Water Budget Evaluation for a Proposed Reservation for Lake Hancock and Lower Saddle Creek in Polk County, Florida

February 2020

Draft

**District Staff Response to an Initial Peer Review of
“Proposed Reservation for Lake Hancock and Lower Saddle Creek
in Polk County, Florida” (Report)**

Figure 1. P11Q residual histogram (Historical vs Baseline scenarios)

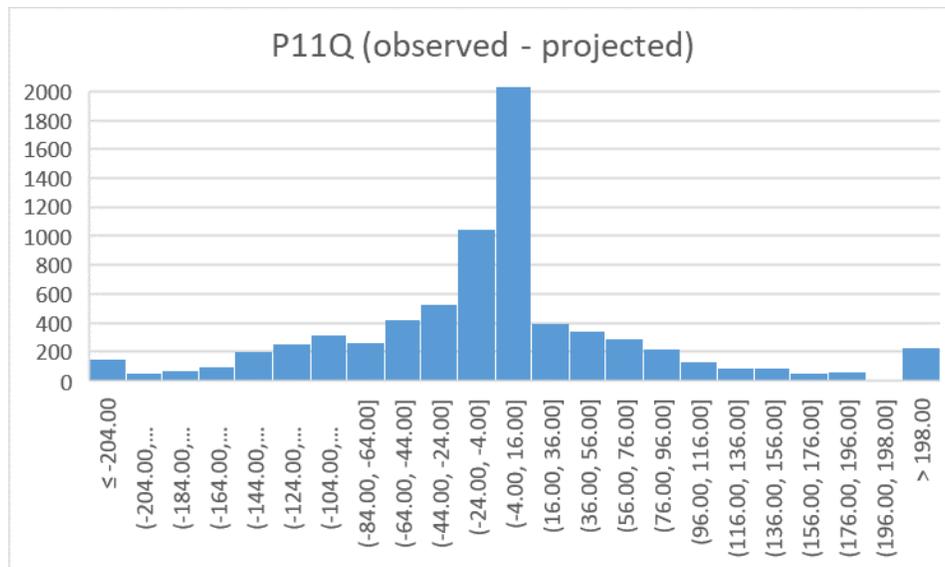
As an example, the piecewise linear functions (Figure 8 page 17) effectively represent the application of the P11 Structure operating rule in the water budget model scenarios for both the baseline (former structure) and current scenarios. Upon inspection of the water budget model Excel file, the residuals (observed – projected) were found to sum to near zero (accounting for wastewater deduction) and appear to be symmetrically distributed (Figure 1) supporting the use of the regression model. Other figures are provided for consideration in the attached comments.

Figure 3 A, B, C. Flow duration curves for P-11 operating scenarios at different scales

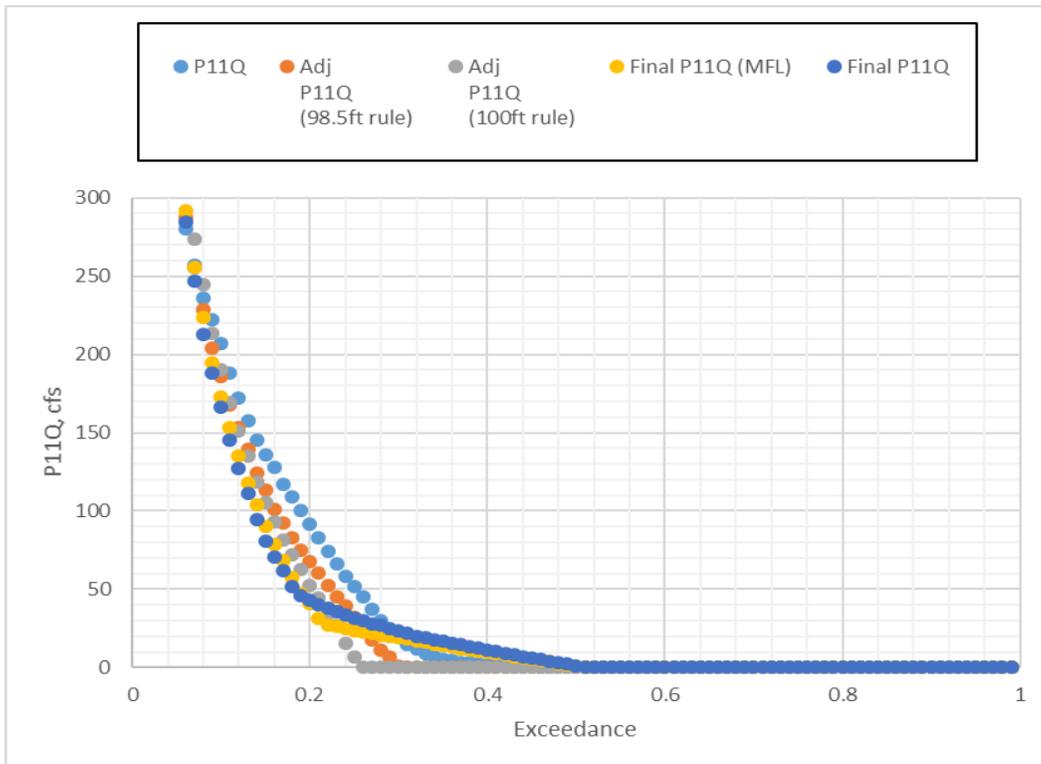
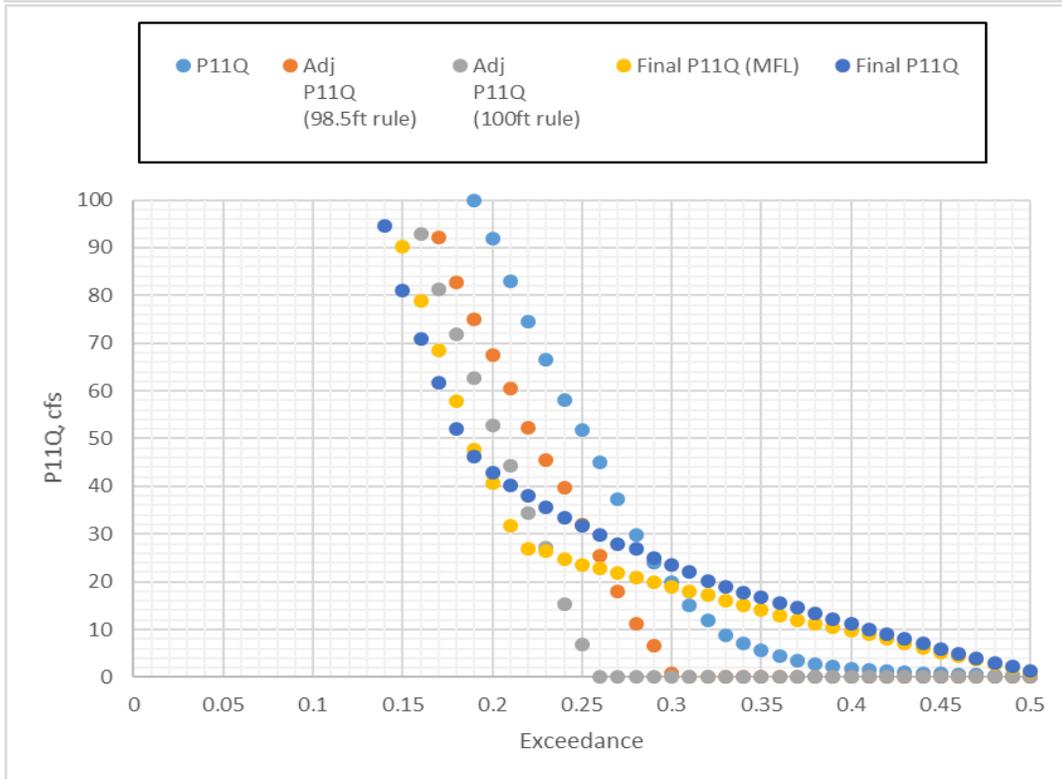
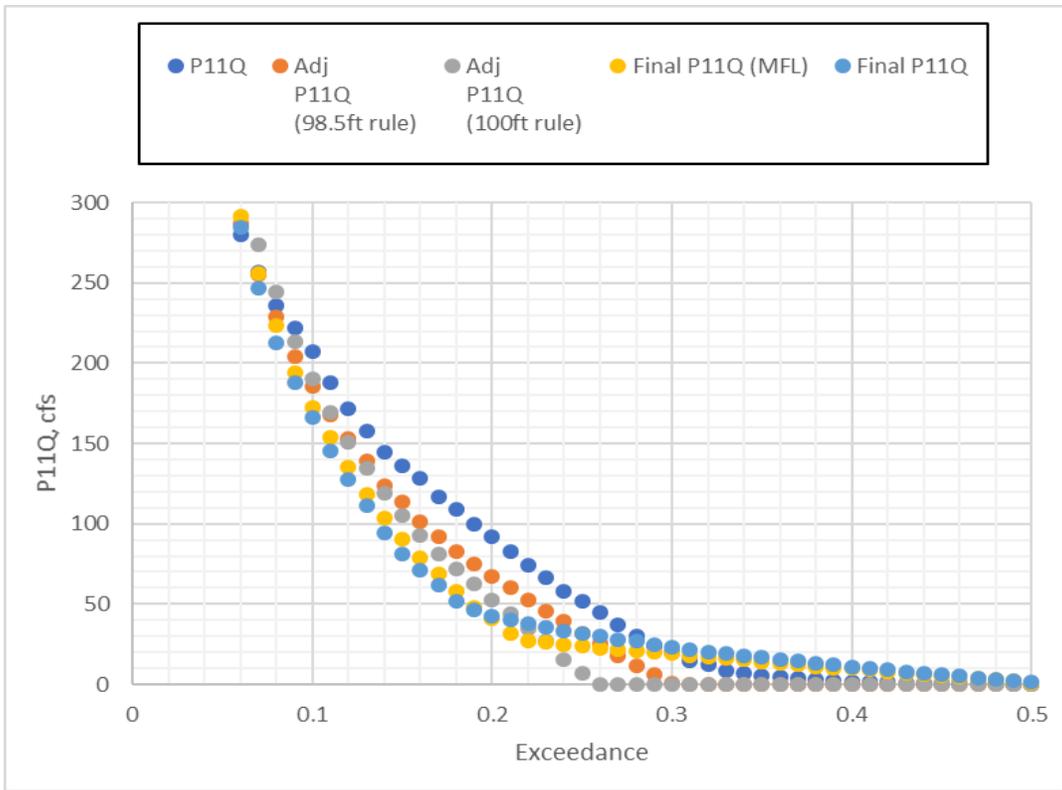
Several duration curves were provided in the comments (Table 1) which may help with displaying the impacts differently than the bar charts presented in the report. For example, Figure 3 (in Attachment A of Table 1) is a lake stage duration curve (SDC) under the various model scenarios along with regulatory levels. Figure 2 (Attachment A of Table 1) depicts flow duration curves (FDC) for the various scenarios and identifies clearly where the MFL augmentation flows are coming from on the FDC, for example.
